ADDENDUM 3

Subject: Bid# 07-085, Replacement of Chillers at the MDR Building

SECTION: PIPING PLAN: MECHANICAL EQUIPMENT ROOM
SCALE: 1/4" = 1'-0"

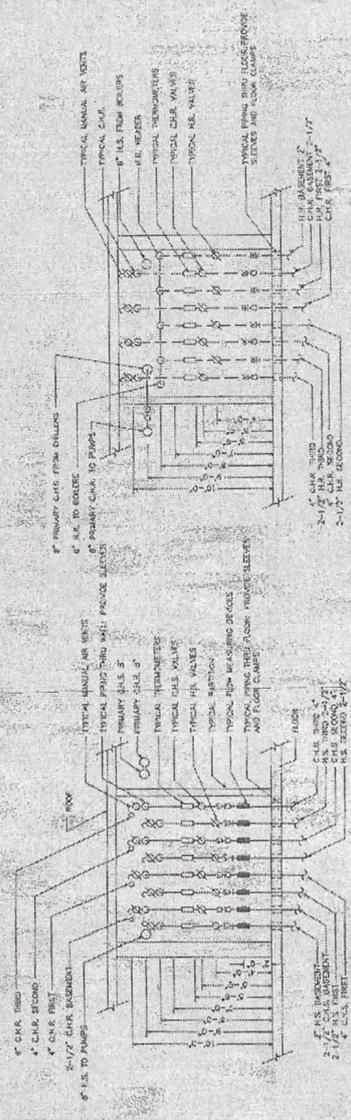
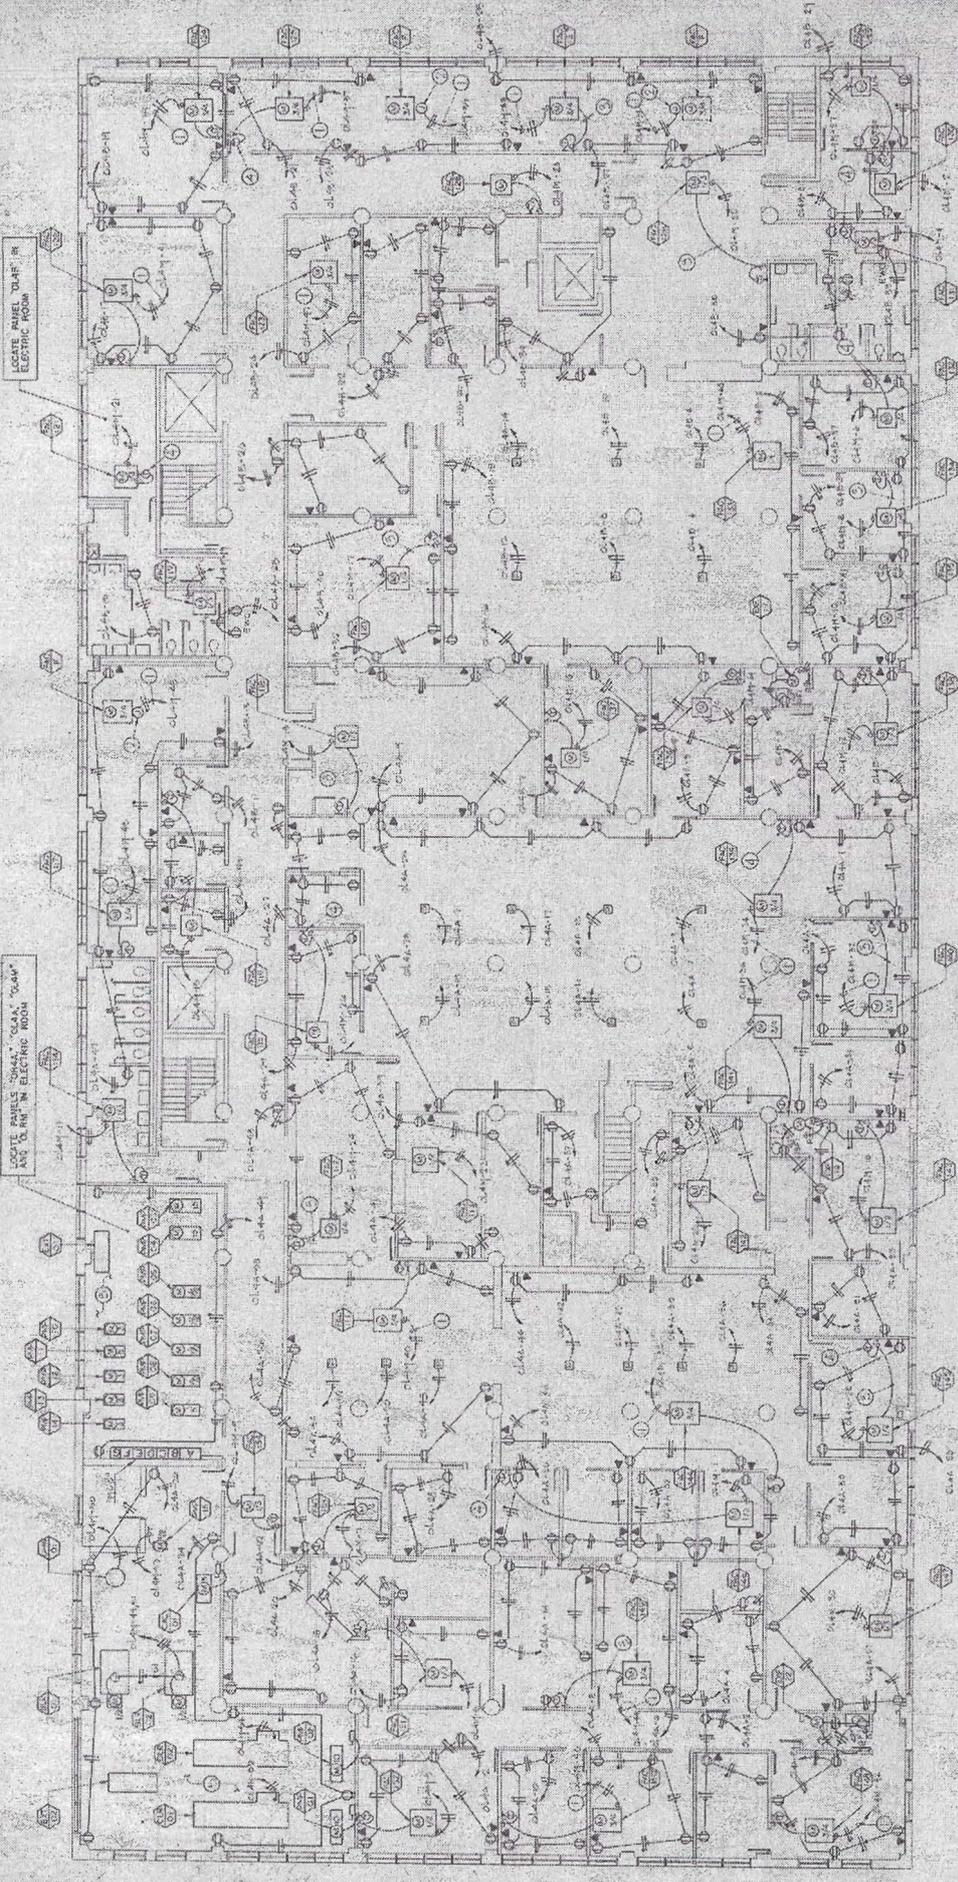
1. Where can we get a set of plans for these projects?

If the vendor is requesting plans for the existing McQuay chillers that will be removed, no documentation exists, to our knowledge. The vendor is welcome to scope, take measurements, and photograph the project site if requested as part of a walk through.

If the vendor is requesting electrical or mechanical prints, no such plans exist, to our knowledge. The vendor is welcome to scope, take measurements, and photograph the project site if requested as part of a walk through.

Please see attached
